ENGINE - DIFFUSER AND COMBUSTION SECTION - INTRODUCE NEW INNER AND OUTER COMBUSTION  
CHAMBER ASSEMBLIES - CATEGORY CODE 7 - MOD.ENG-72-0159

V2500-ENG-72-0159

Location of the Outer Combustion Chamber Assembly  
Fig.1

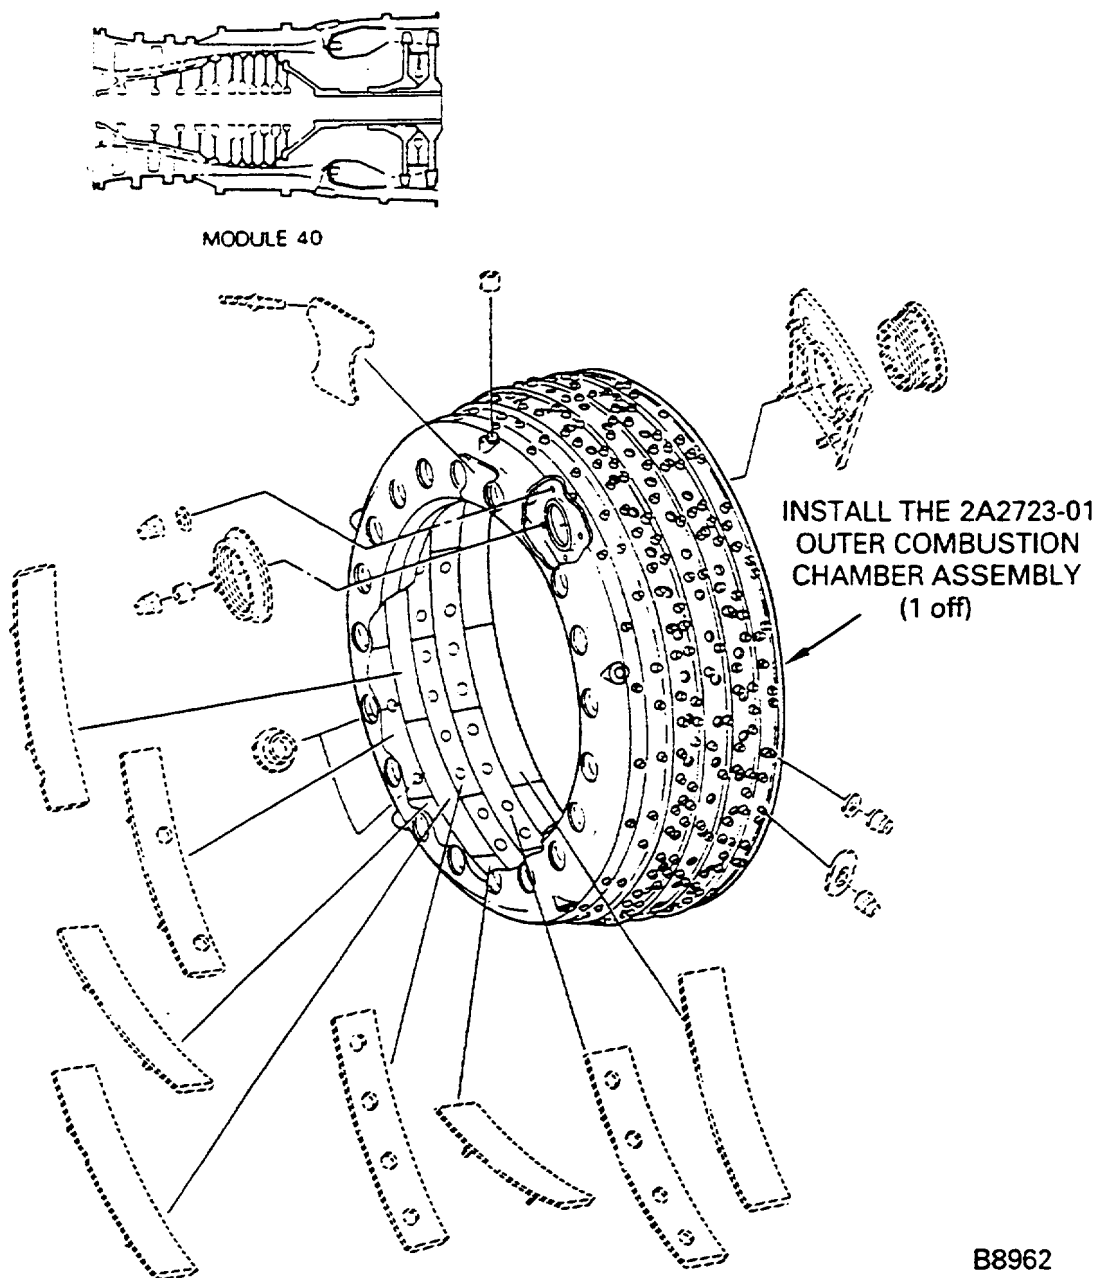
- (1) Replace the Outer Combustion Chamber Assembly with one that has:
- (a) a modified rear seal
  - (b) new liners with added holes and revised hole patterns.
  - (c) a new hood liner with a revised cooling hole pattern and an increased hardcoating thickness on the hood
  - (d) new liner segments commonly used in V2500-A1 Engines
  - (e) a new liner assembly with a revised hole pattern and additional hardface on the forward liner.
- (2) Replace the Inner Combustion Chamber Assembly with one that has the following features:
- (a) new liner segments commonly used in V2500-A1 Engines
  - (b) a new liner assembly with a revised hole pattern and additional hardface on the forward liner.

- (a) Install the 2A2723-01 Outer Combustion Chamber Assembly (1 off) by the approved procedure given in Reference (2), Chapter/Section 72-42-00, Assembly, and Figure 1.
- (b) Install the 2A2722-01 Inner Combustion Chamber Assembly (1 off) by the approved procedure given in Reference (2), Chapter/Section 72-44-00, Assembly, and Figure 2.

- (a) Install the 2A2723-01 Outer Combustion Chamber Assembly (1 off) by the approved procedure given in Reference (3), Chapter/Section 72-42-00, Assembly, and Figure 1.
- (b) Install the 2A2722-01 Inner Combustion Chamber Assembly (1 off) by the approved procedure given in Reference (3), Chapter/Section 72-42-00, Assembly, and Figure 2.
